APPENDIX I. SECTION 4(F) EXHIBITS AND CORRESPONDENCE

Meeting: I-94 Modernization Supplemental EIS Meeting with the Michigan State Historic Preservation Office (SHPO)

Meeting: MDOT and DNR Iron Belle Trail Section 4(f)

PROPOSED PROPERTY IMPACTS TO SQUARE D/DETROIT FUSE

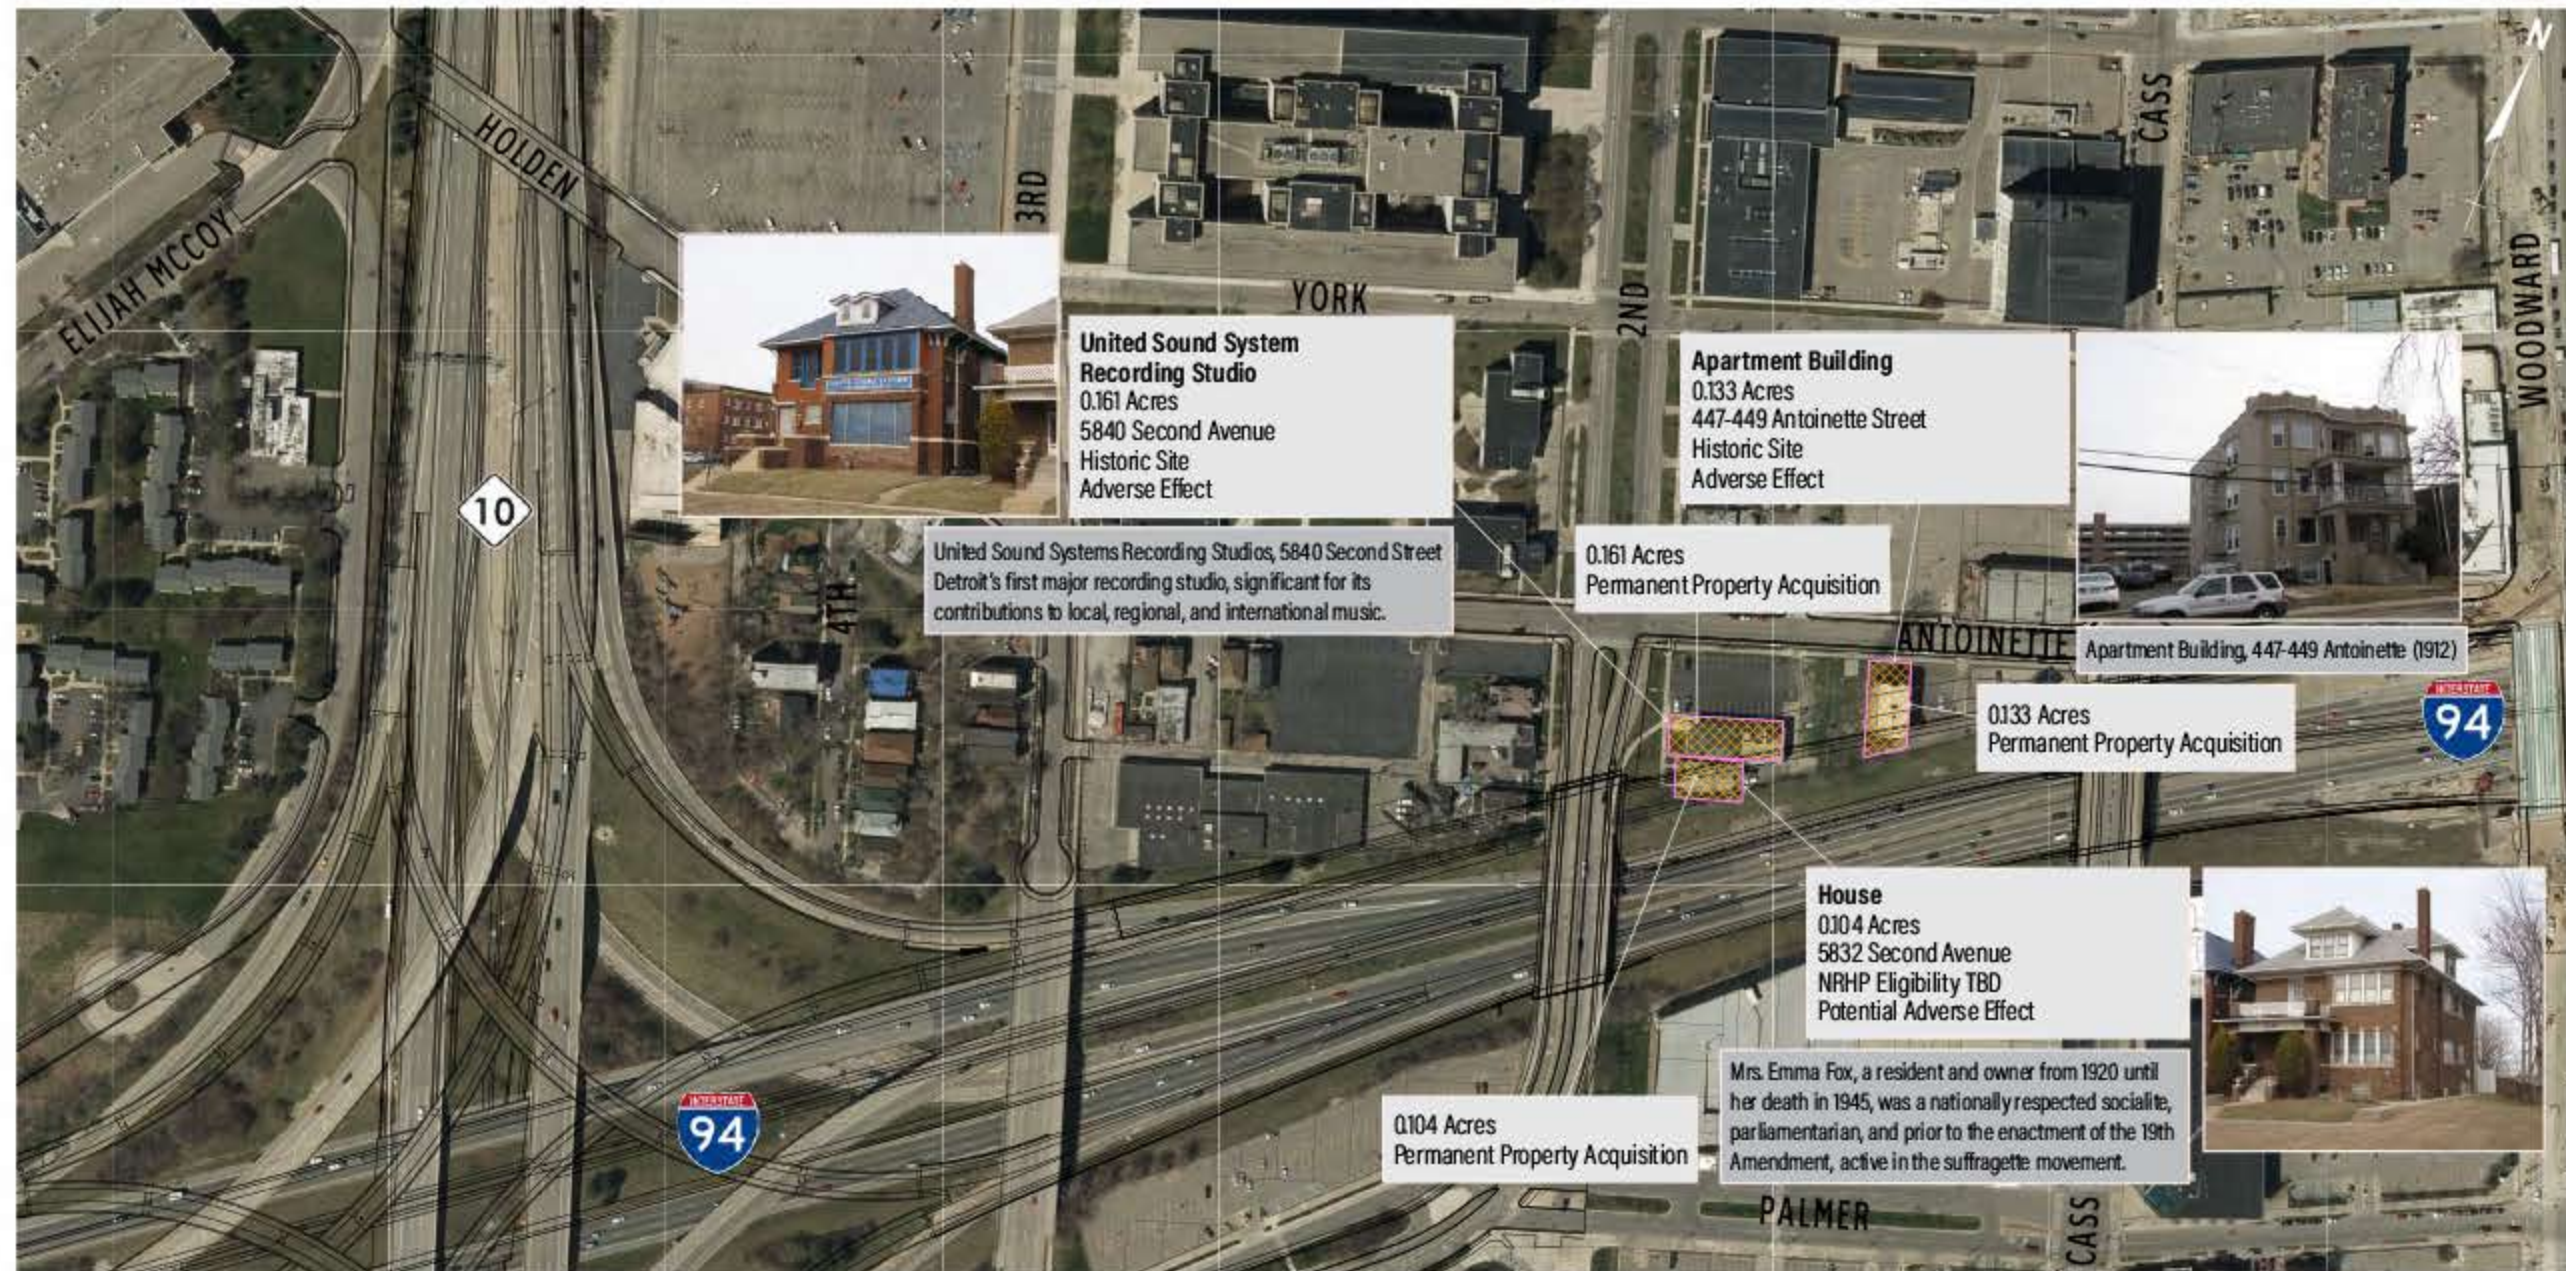
Other historic sites within the study corridor were briefly discussed. It was questioned whether Square D (6060 Rivard Street) was still extant. It was reported that the house at 5287 Hecla Street has an interested buyer who wants to move it to an adjacent lot and renovate it. This would move it out of the area of impact.
